From: Scala, Mary Joy
Sent: Wednesday, September 23, 2015 4:37 PM
To: Powe, Gregory; Woodard, Keith
Subject: BAR Action – September 15, 2015 – 200 2nd Street SW

Certificate of Appropriateness Application

BAR 15-09-07
200 2nd Street SW
Tax Parcel 280069000, 280071000-280075000
Powe Studio Architects, Applicant/Market Plaza LLC, Owner
Refinements to building and plaza and landscape design

**CITY OF CHARLOTTESVILLE
BOARD OF ARCHITECTURAL REVIEW
STAFF REPORT
September 21, 2015**

Site Materials Diagram, Plaza Plan and Paving Detail Plans

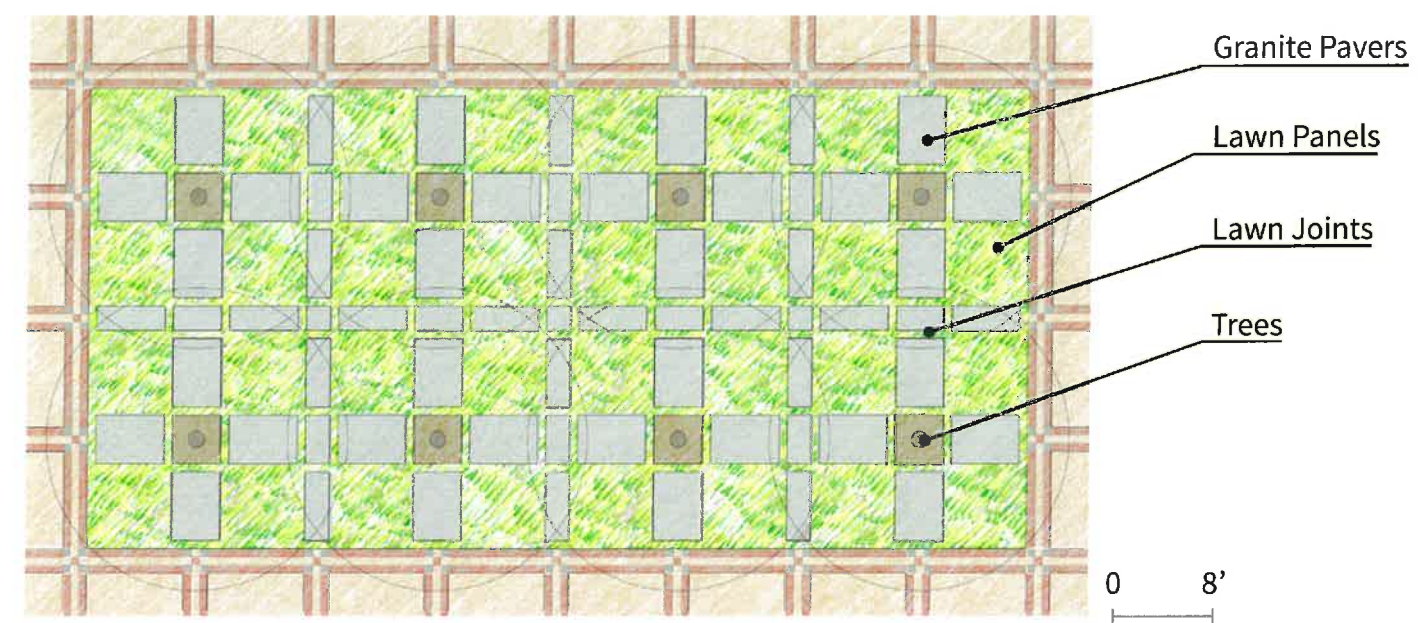
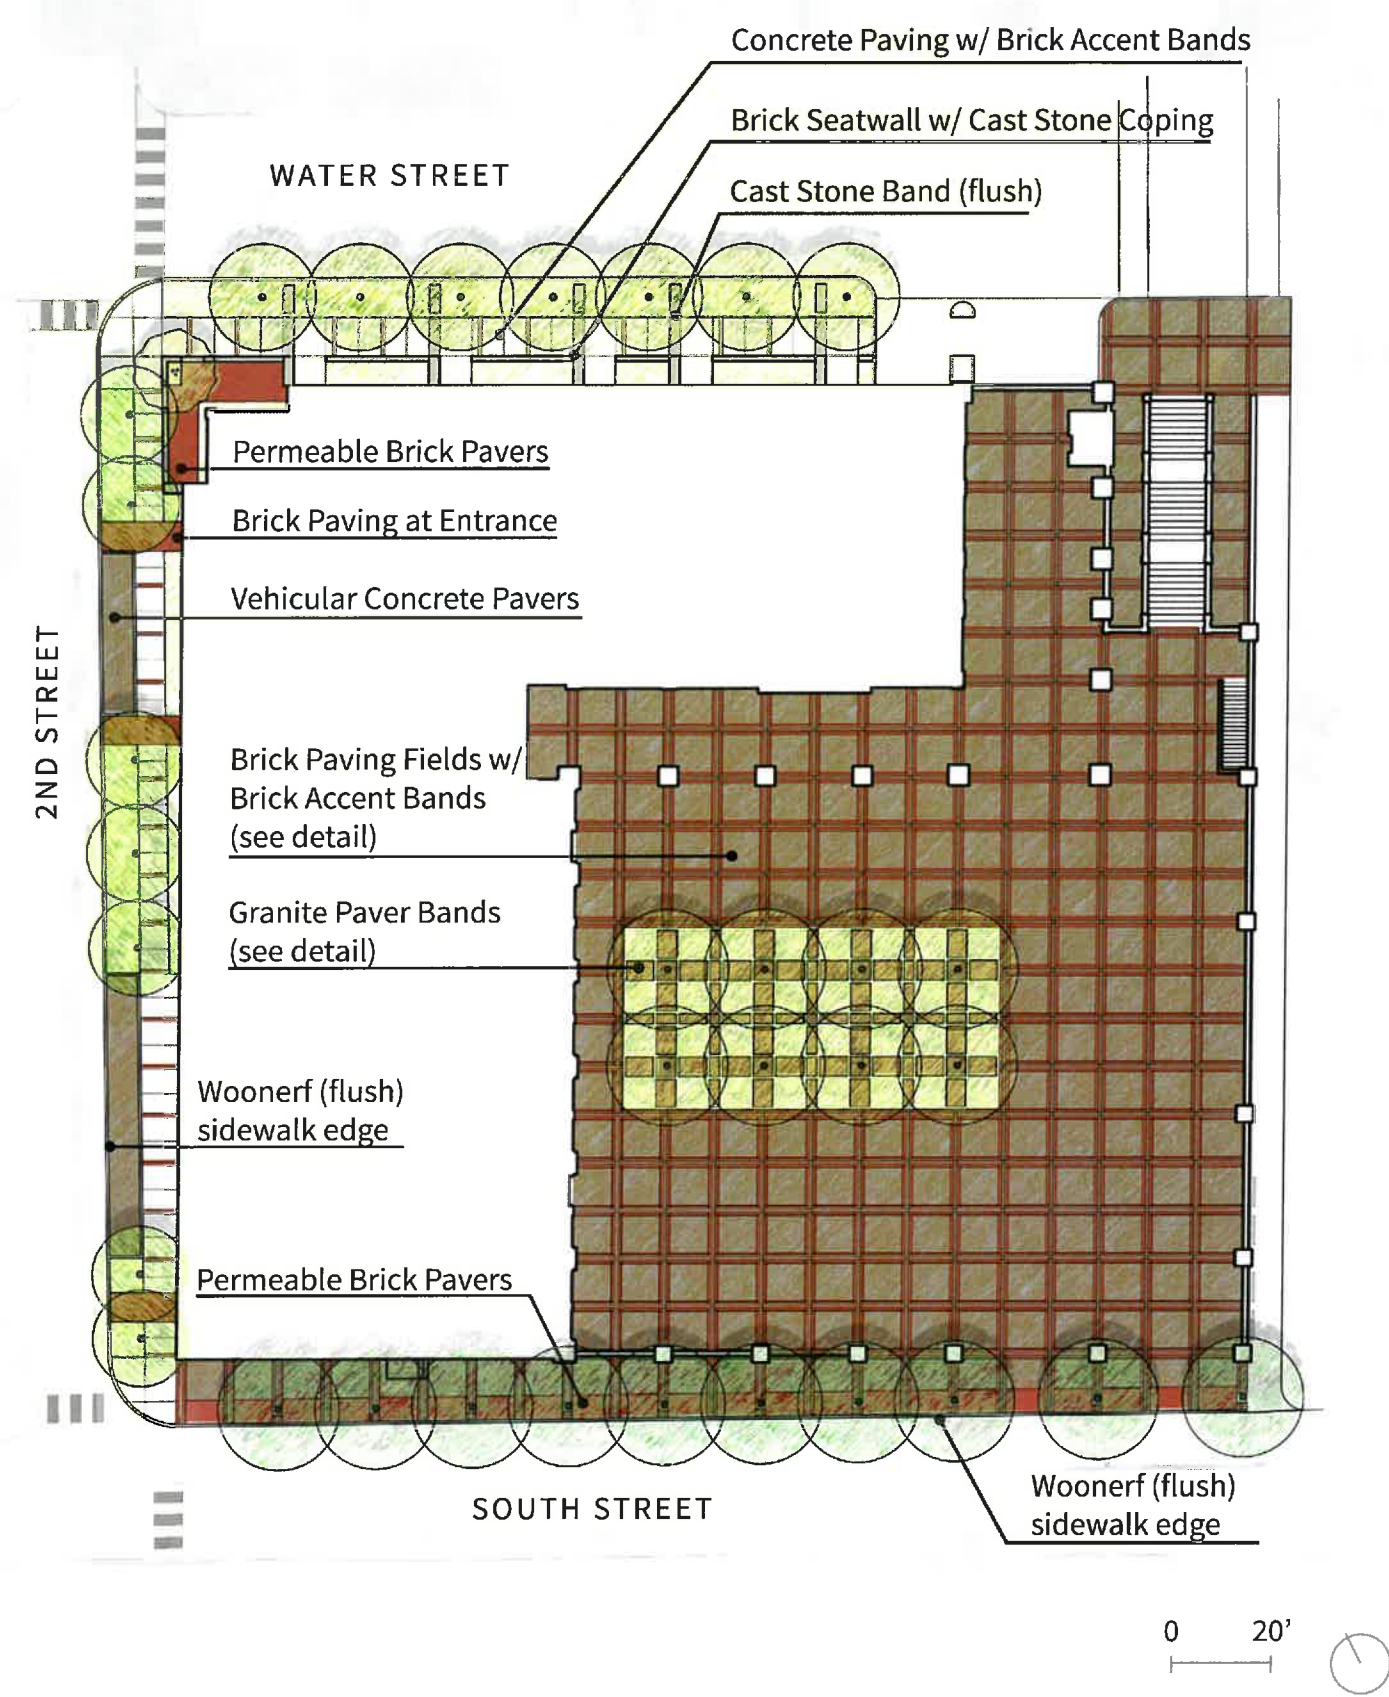
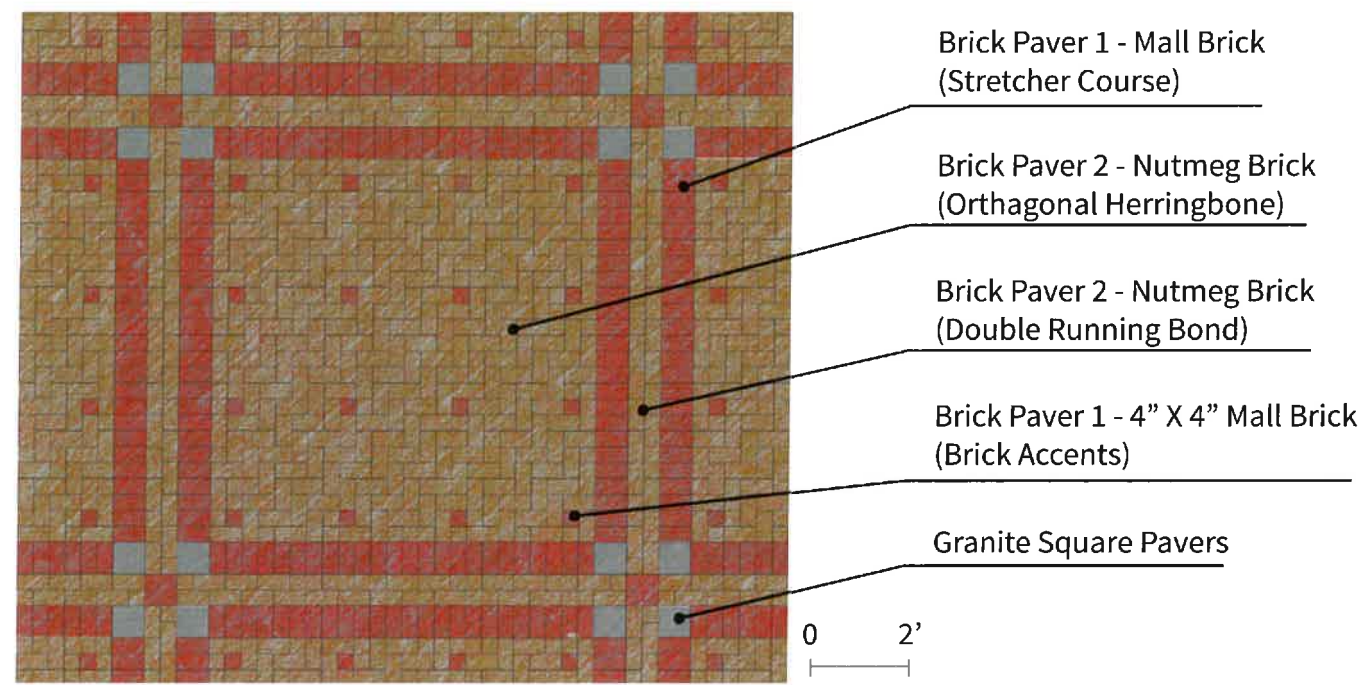
- Will the lawn area appear as depicted on Sheets 3A-4B, or divided up as shown on Sheets 8 and 10?
- Better depictions are needed for the new stair landing on South Street; the new stair that replaces the retaining wall on South Street; and the new stair to the parking garage located on the plaza near 1st Street.
- A cut sheet or more details for the fold up doors at events space.
